Agenda
City of Springboro Planning Commission Meeting
Wednesday, November 13, 2024, 6:00 p.m.
Council Chambers, City Building, 320 West Central Avenue

Record Plan, Northampton, Phase 1, 1525 South Main Street (SR 741), residential subdivision

Site Plan Review, Midway Plaza shopping center, exterior façade changes

PREPARED BY: **Submitted for Review** ChoiceOne Engineering
DATE: 10-31-2024
DRAWN BY: MPL
JOB NUMBER: WARSPR2303
SHEET NUMBER: 1 OF 2

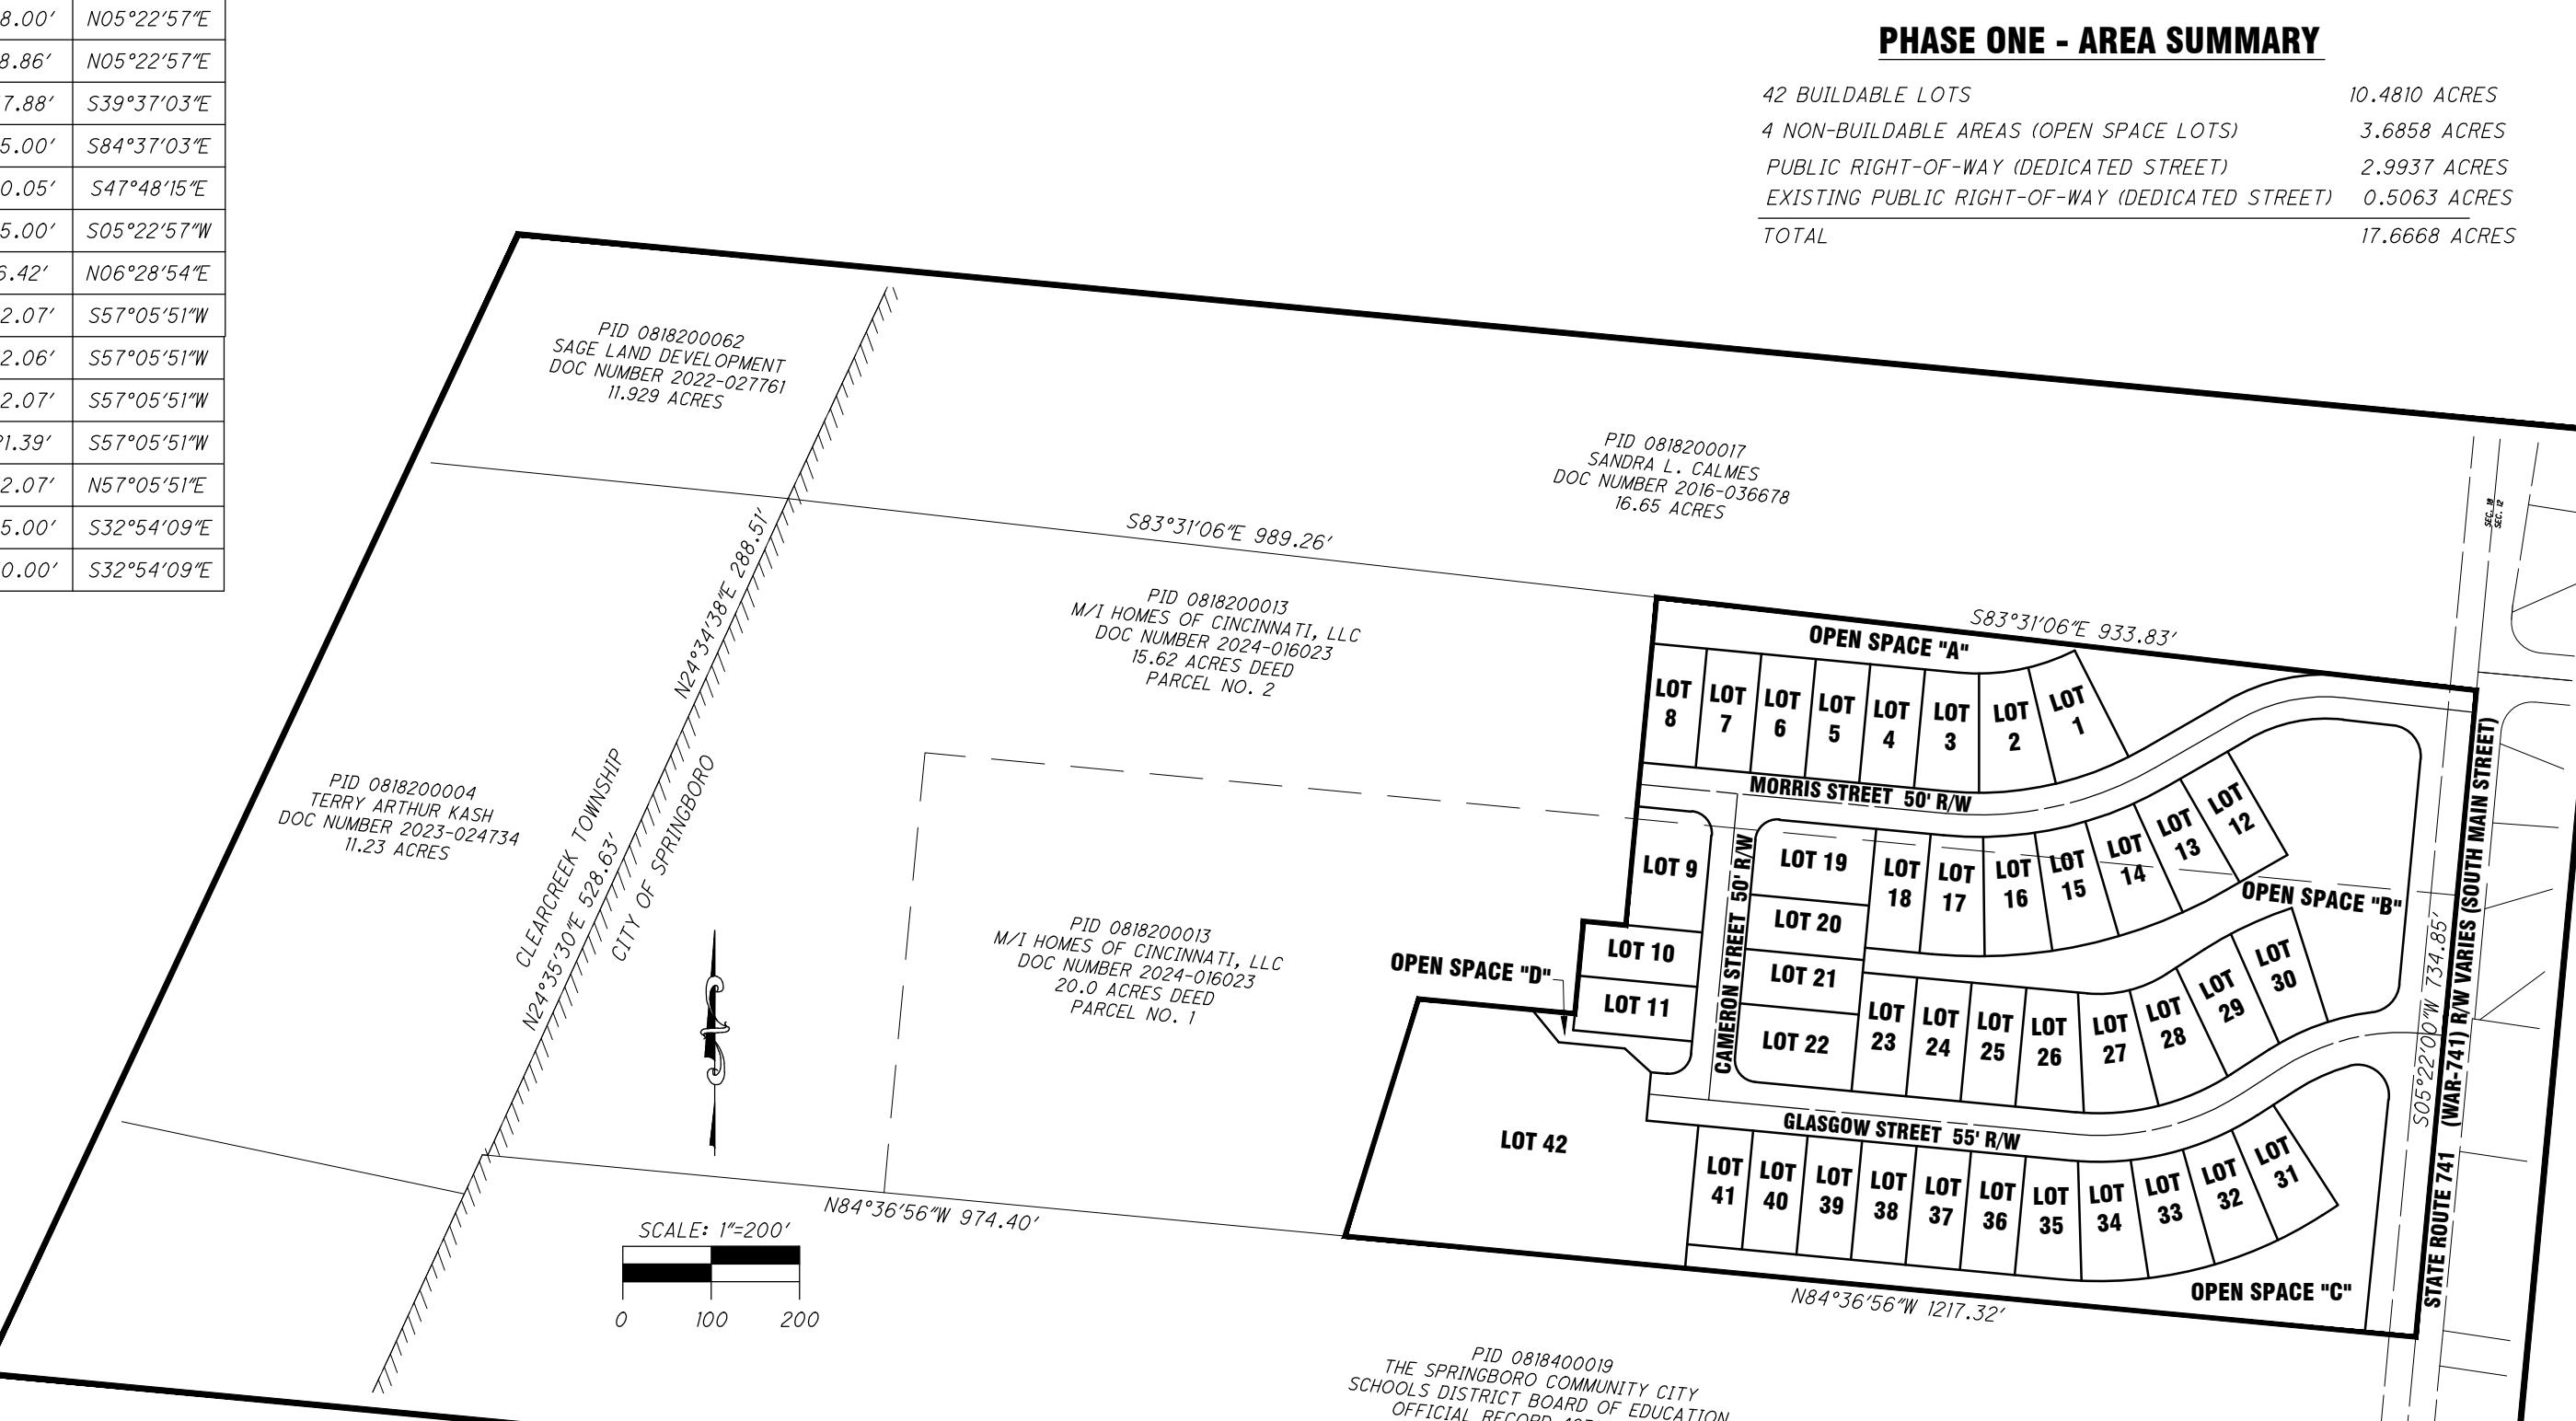
1. Revise city approval signature blocks.
2. Provide minimum square foot dwelling size on sheet 2 under the Typical Lot detail.
3. Provide HOA documents for review and approval. Add the HOA recording information in General Notes.
4. Revise General Notes comment #5 to include bike lanes as an HOA maintenance item.
5. Submit to Warren County for review and revise accordingly.

All That Dance Existing Elevation

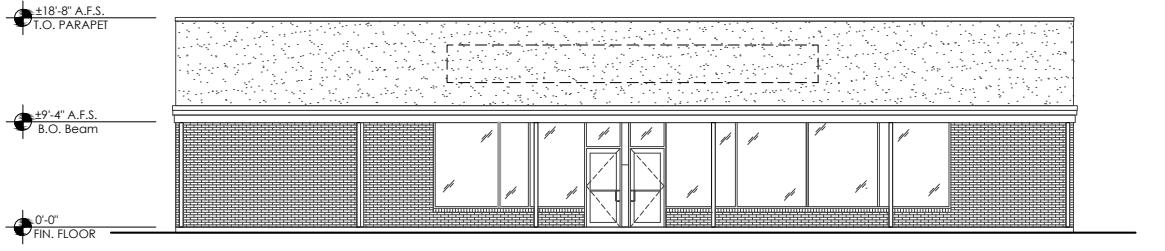
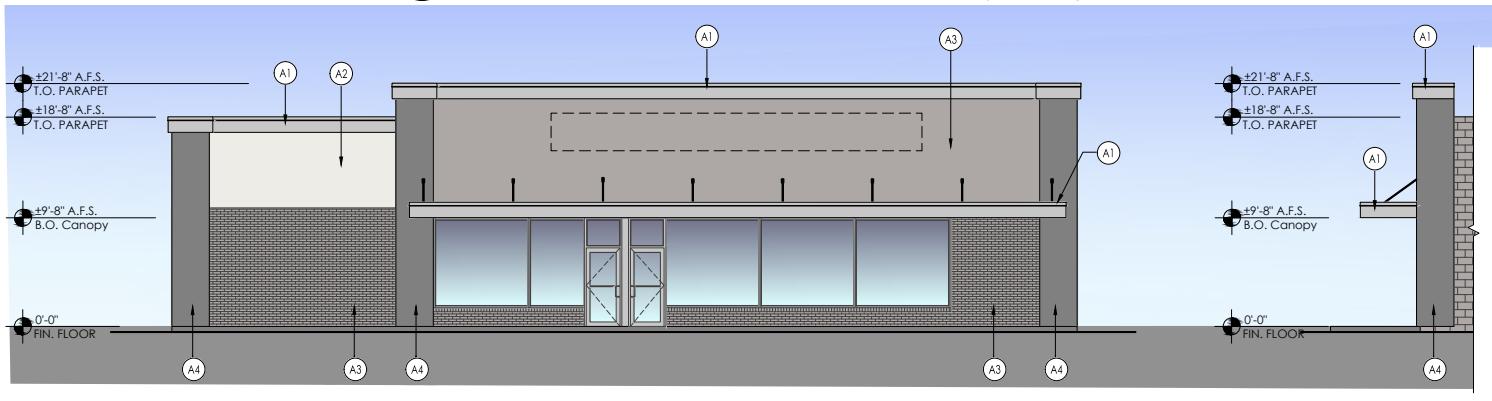
For the All That Dance building, the applicant proposes to modify the front/west elevation by removing the existing (upper) stucco facade, canopy, and columns. Those would be replaced by a new brick and EIFS façade with an asymmetrical design, and a new canopy and sign placement. The existing storefront system (windows, doors) would remain.

1. Coordinate with Zoning Inspector following Planning Commission's action on plans for the signage relocation and any required permitting.
2. For proposed lighting, select a fixture that is flush-mounted, then submit new fixture selection and photometric analysis for adjacent areas indicating lighting levels to a maximum of 6.0 foot-candles.

Midway Plaza Existing Elevation

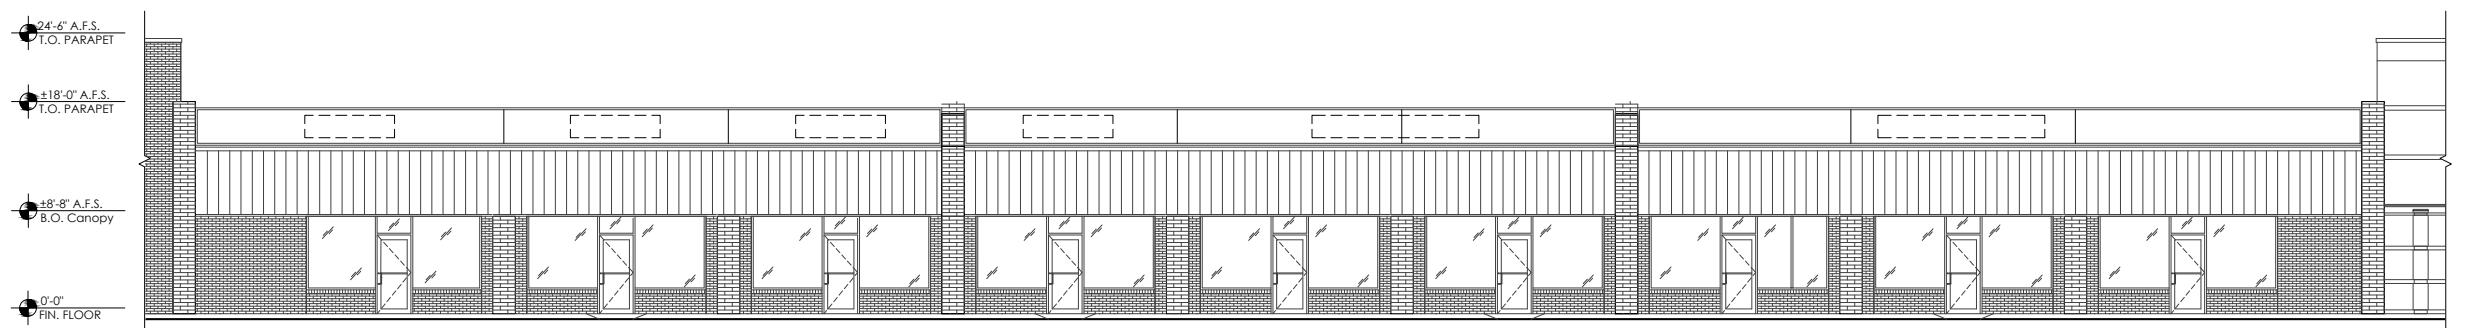
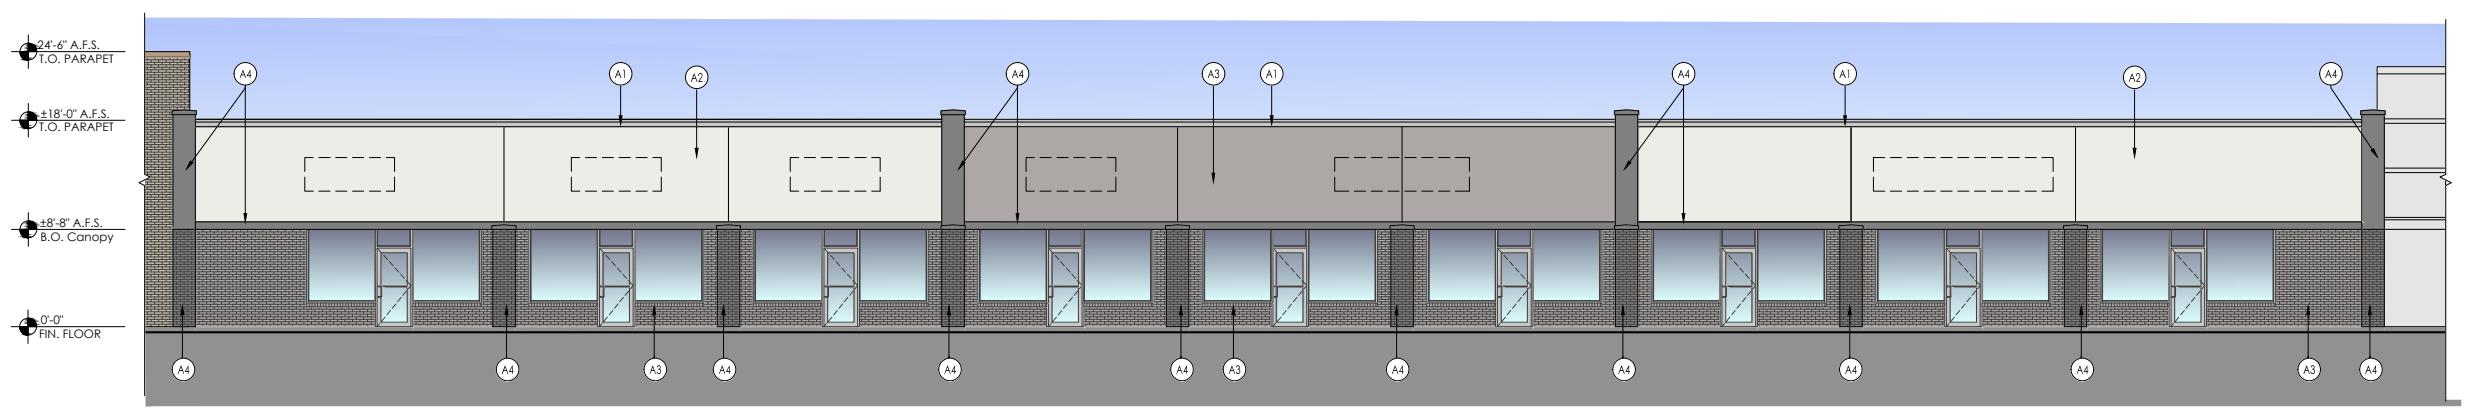
For the multi-tenant portion of the main shopping center building, the existing yellow canopy and soffits will be removed as well as the arch-shaped portions of the canopy support columns. The covered walkway in this portion of the shopping center would remain under a new canopy, and the upper portion of the façade would move forward. Signage for the tenants in this portion of the shopping center would be relocated as indicated in the submitted plan.
